**California Public Utilities Commission
Collinsville 500/230 kV Substation Project
Final Environmental Impact Report, Volume I:
Responses to Comments on the
Draft Environmental Impact Report
State Clearinghouse No. 2025010149**

March 2026

Figure 3-1 Estimated Maximum HDD Distance from Delta Shoreline

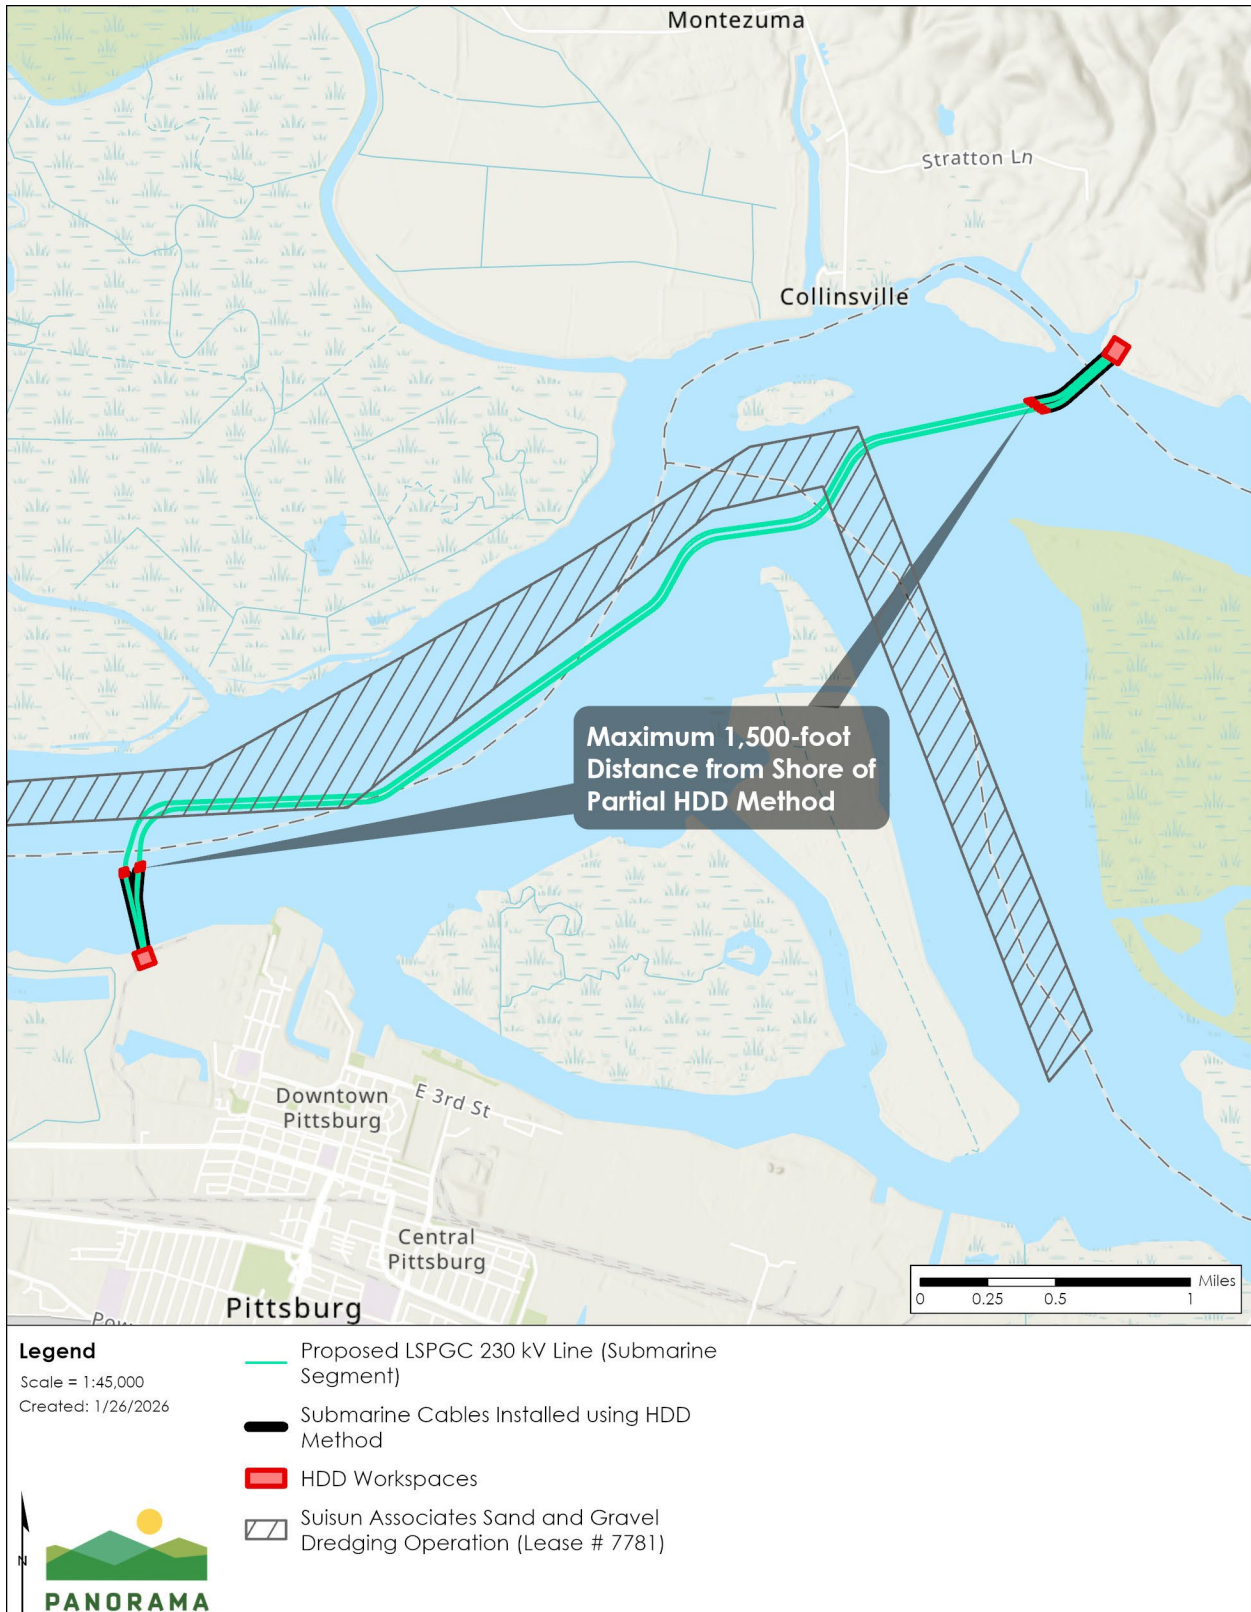
safe pressure window between bore collapse and hydraulic fracture. As shown in Figure 3-1 below, these distances only cover a portion of the 4.5-mile Delta crossing. The 1,500-foot distance limitation would not be sufficient to avoid the proposed trenching methods within the sand and gravel mining lease area (refer to Figure 3-1 in this response). HDD methods would require additional workspaces beyond those identified for the Proposed Project (refer to Figure 3-1) and the risk of a potential frac-out that could impact the environment. Further, according to LSPGC, the required depths of the HDD would introduce additional cables required in order to meet specified cable ratings resulting in additional impacts and time constraints.

The Alternatives Screening Report in the revised Draft EIR (Appendix C) was updated to include Figure 3-1. In addition, the description of the two HDD alternatives and the rationale for rejecting them was updated for clarity.

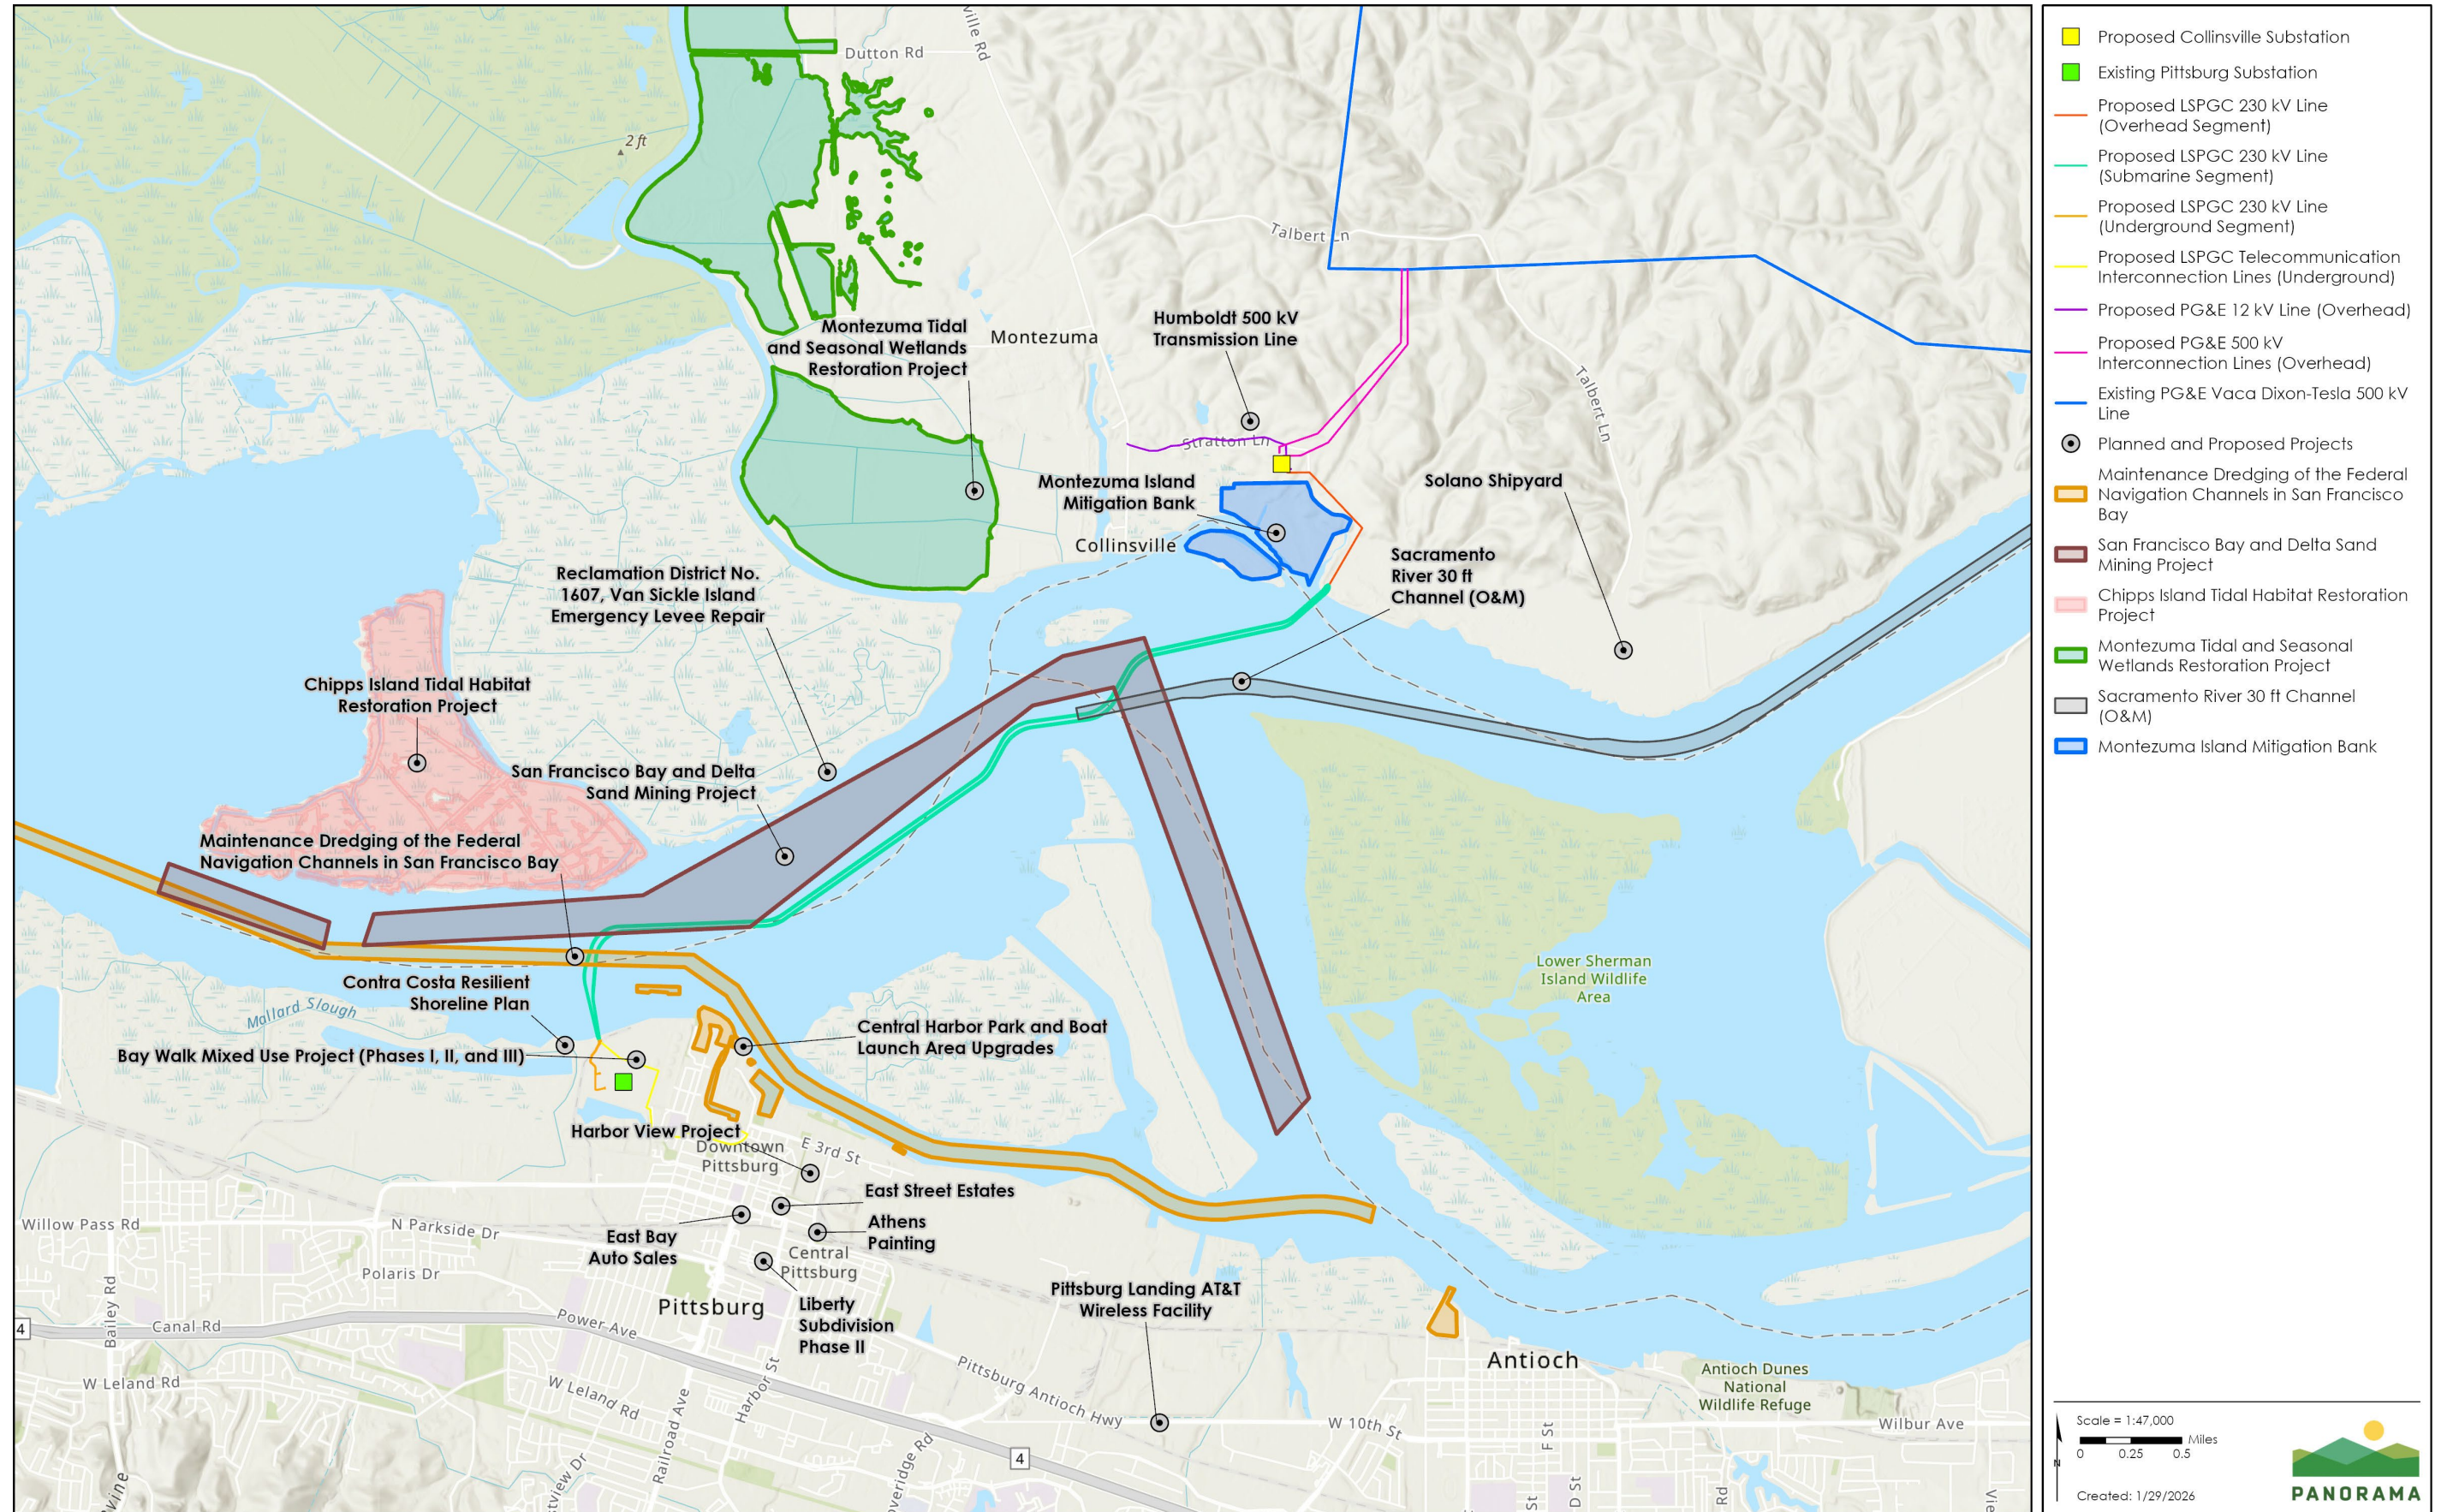
Comment Number	DEIR Page #	DEIR Paragraph or Table #	Original DEIR Text	Comment	
28	4.0-3	Last paragraph, Second sentence	The locations of the cumulative projects are shown in Figure 4.0-1.	Not all projects listed in Table 4.0-1 are visible on Figure 4.0-1. A note should be added to this section indicating that projects without sufficient location data were not mapped and indicate which ones have not been mapped.	L-1-28

The Montezuma Island Mitigation Bank has been added to Table 4.01-1 and Figure 4.0-1 was revised as follows:

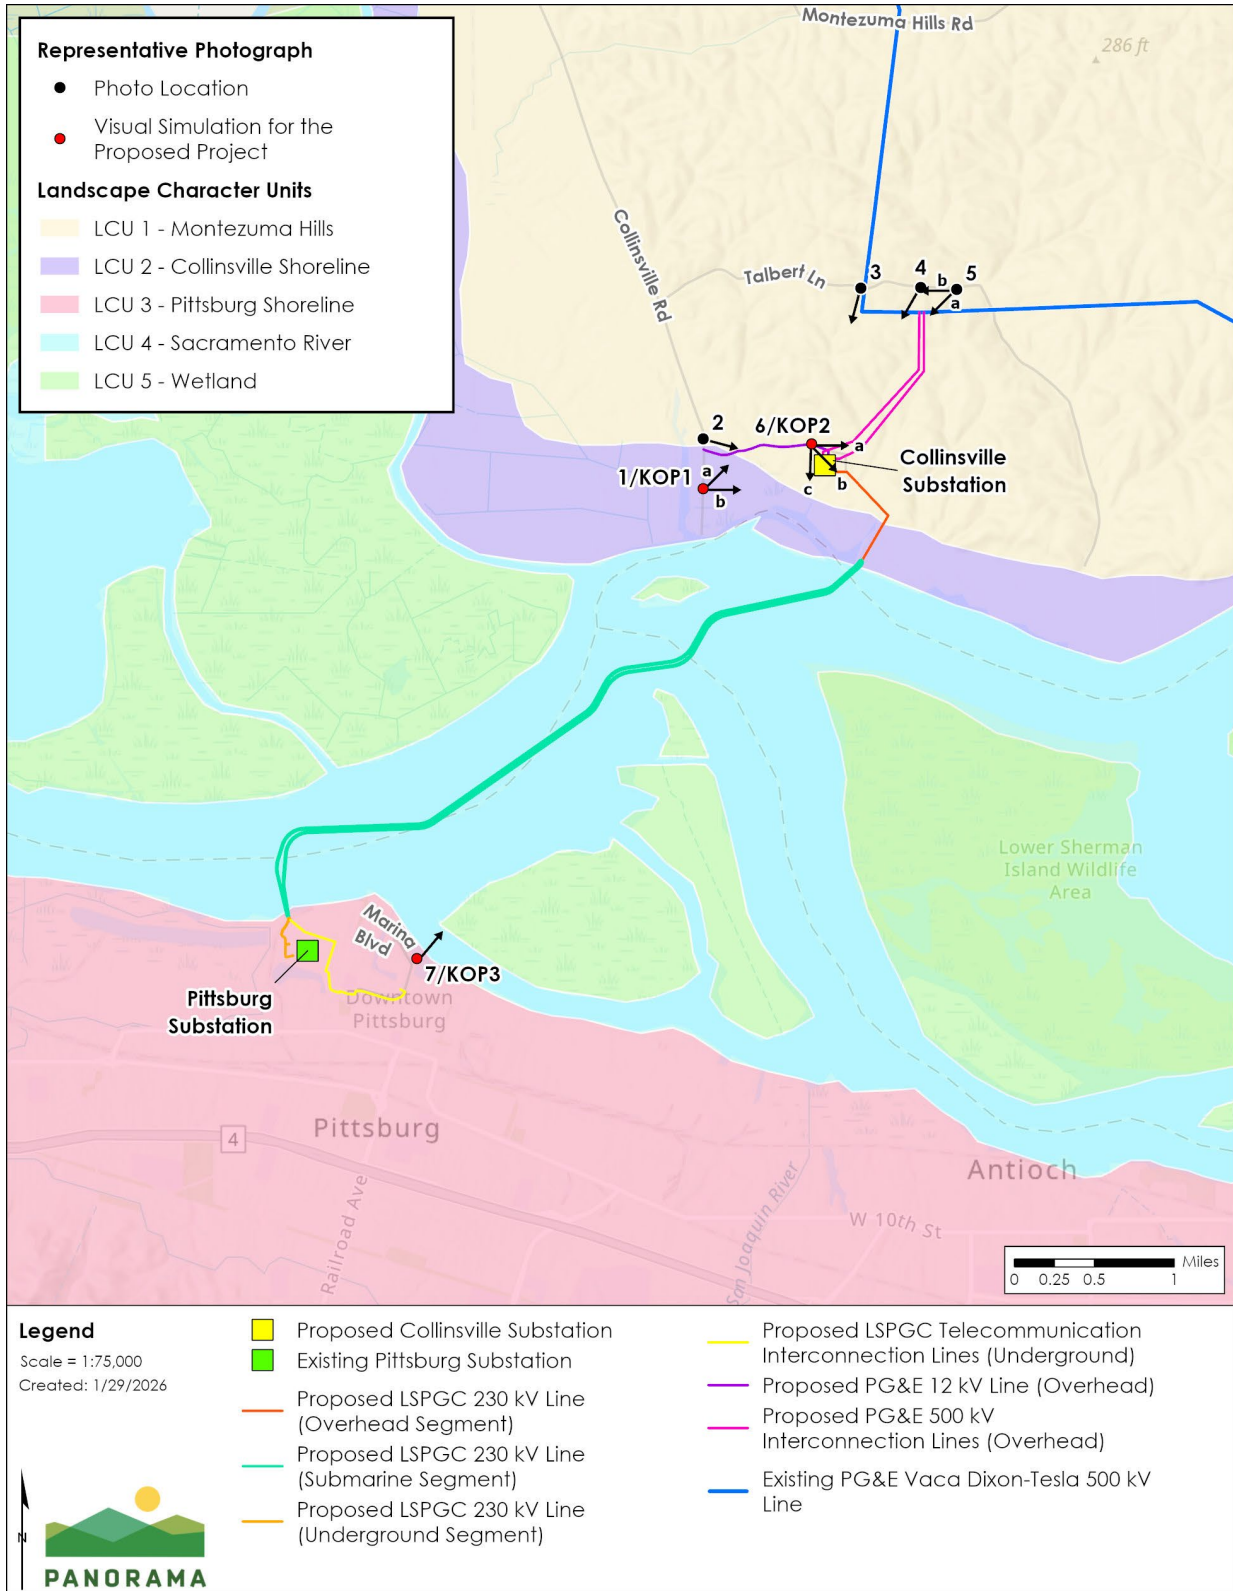
4.1 Aesthetics					
29	4.1-6	Figure 4.1-1	Figure 4.1-1 Landscape Character Units, Representative Viewpoints, and Key Observation Points	The label for Photo Location 6/KOP 2 is missing. Please add the label for consistency.	L-1-29
30	4.1-26	Table 4.1-7	"Overall, the resulting visual impact at KOP 1 would be perceptible, and the Proposed Project would reduce the natural harmony and project coherence by introducing a cultural infrastructure (i.e., built by man) into a perceived natural landscape."	The DEIR states that KOP 1 includes existing energy infrastructure (wind turbines). The statement "perceived natural landscape" therefore appears to be a misrepresentation of the existing conditions. Recommend revising this statement for clarification that KOP 1 includes existing energy infrastructure and that addition of the Proposed Project while additive, would be consistent with existing conditions.	L-1-30

L-1-29 LSPGC requests the addition of a label for Photo Location 6/KOP 2 within Figure 4.1-1 of Section 4.1, Aesthetics.

Figure 4.1-1 has been revised to show KOP 2 as follows:
